Blown fuse, compressor - air suspension

REF NO: TJ 31423.14.0	ISSUING DEPARTMENT: Technical Service	CAR MARKET: United States and Canada	
PARTNER: 3 US 7510 Volvo Car USA		ISSUE DATE: 2019-04-01	STATUS DATE: 2019-04-11
FUNC GROUP: 7641	FUNC DESC: Level control, complete	Page 1 of 15

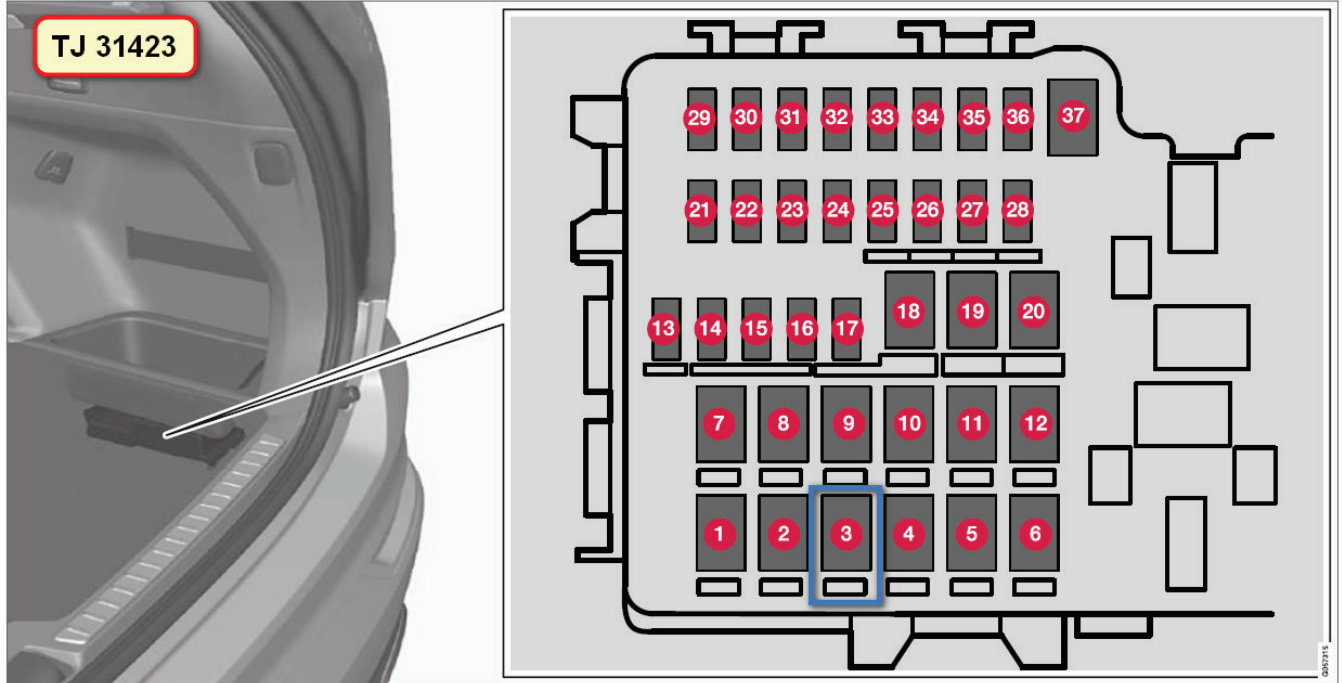
Improved compressors have been introduced in production (and spare parts) from March 2019, these are marked with a white dot, refer to picture [TJ 31423 - 1.jpg](#).

Note: The concerned fuse is located in the cargo area right side under the storage compartment, fuse number 3, refer to picture [TJ 31423 - 2.jpg](#).

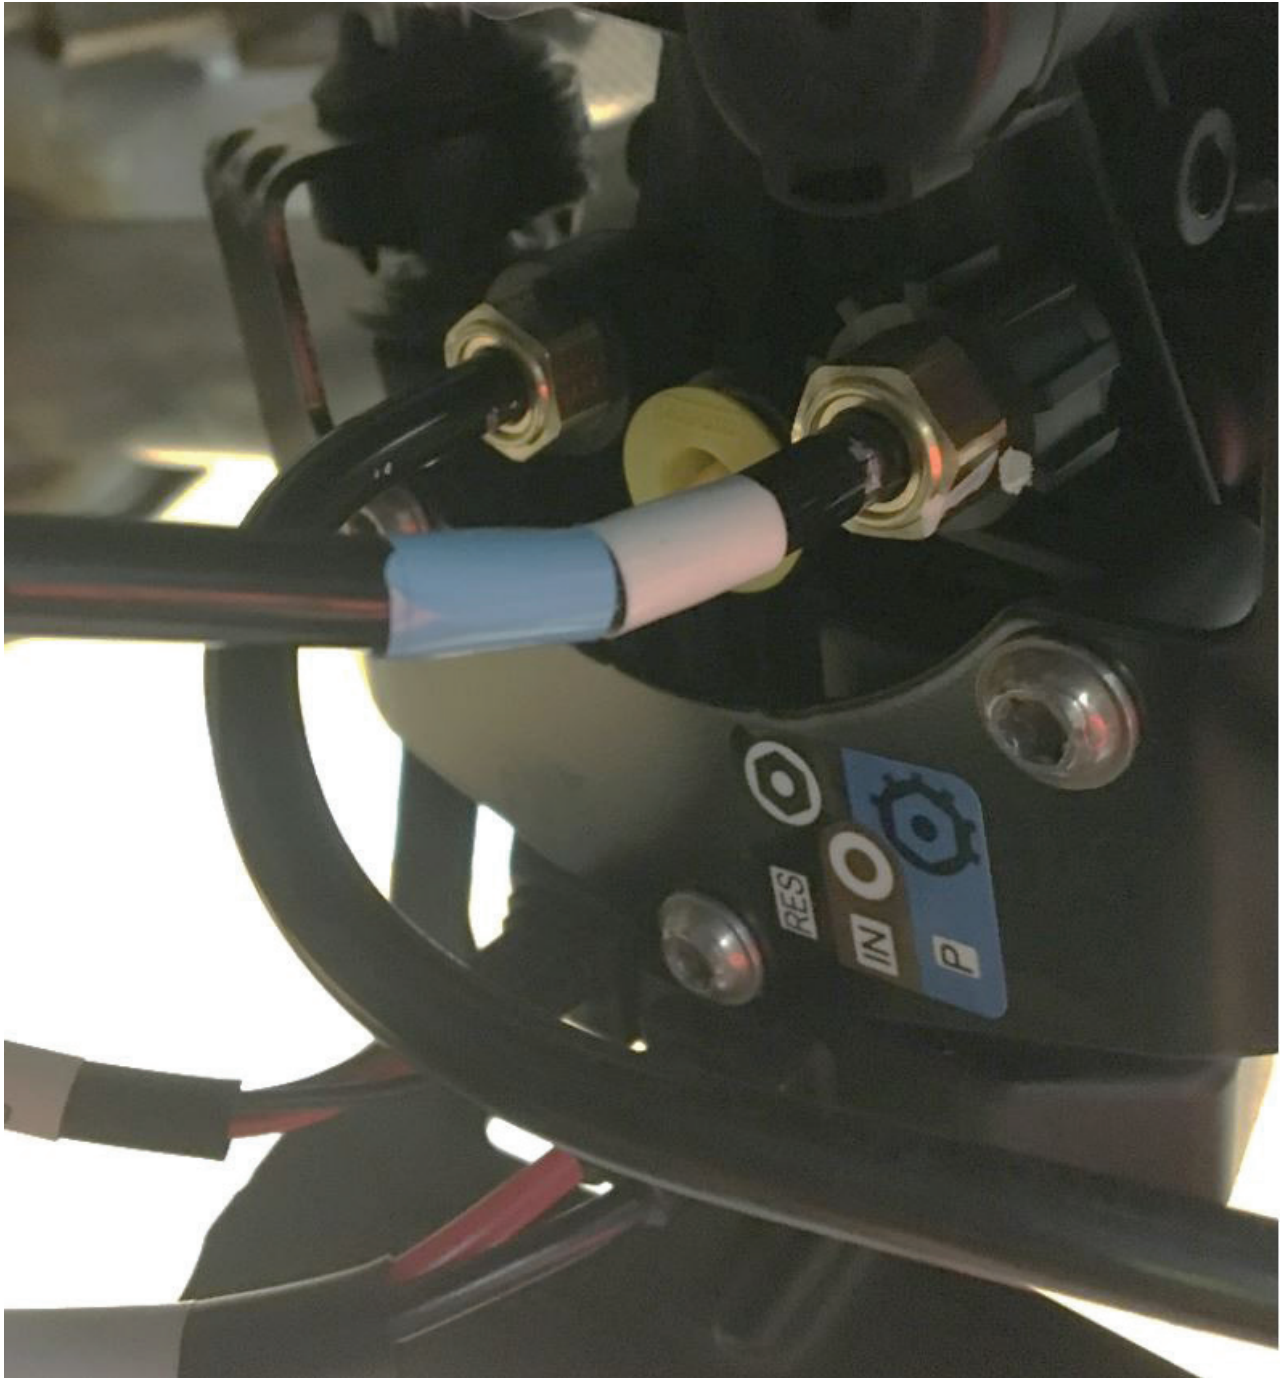
Note. Pay attention to which hose is connected to where on the compressor. See attached picture, [Air suspension hoses to compressor.jpg](#).
